CONDITIONS OF APPROVAL
1320 HOLLYWOOD BLVD
CERTIFICATE OF APPROPRIATENESS OF DESIGN
25-C-101

Certificate of Appropriateness for Design to construct a new single-family in the RS-6 Zoning District, and within the Hollywood Lakes Historic District.

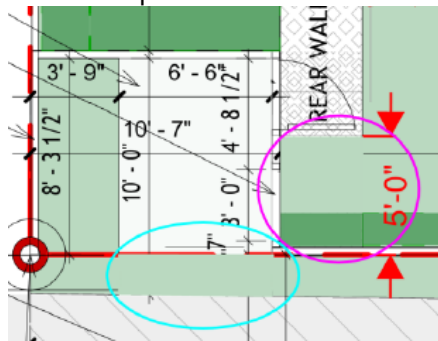
- a. The driveway is shown as 10'-6" and the apron is shown as 9'-1". The proposed 10'-6" driveway is permissible. Apron must be the same width as the driveway. The apron is to be reinstalled to match the width of the driveway on private property. This approval is contingent on obtaining approval from Florida Department of Transportation for a new apron to be installed to match the proposed 10'-6" driveway width on private property.

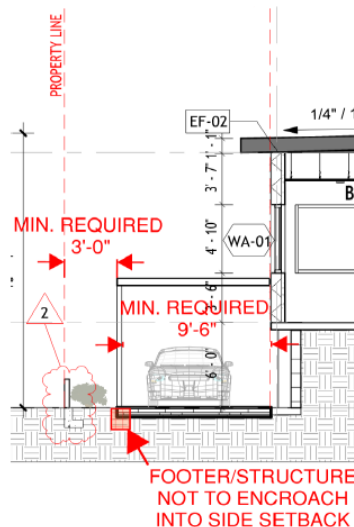
- b. Rear walkway to Trash Bay shall be setback a minimum of 5 feet from the rear property line. Please provide setback and shift access door for brush bay to align with walkway setback requirements. Slab for trash bay shall stop at property line.
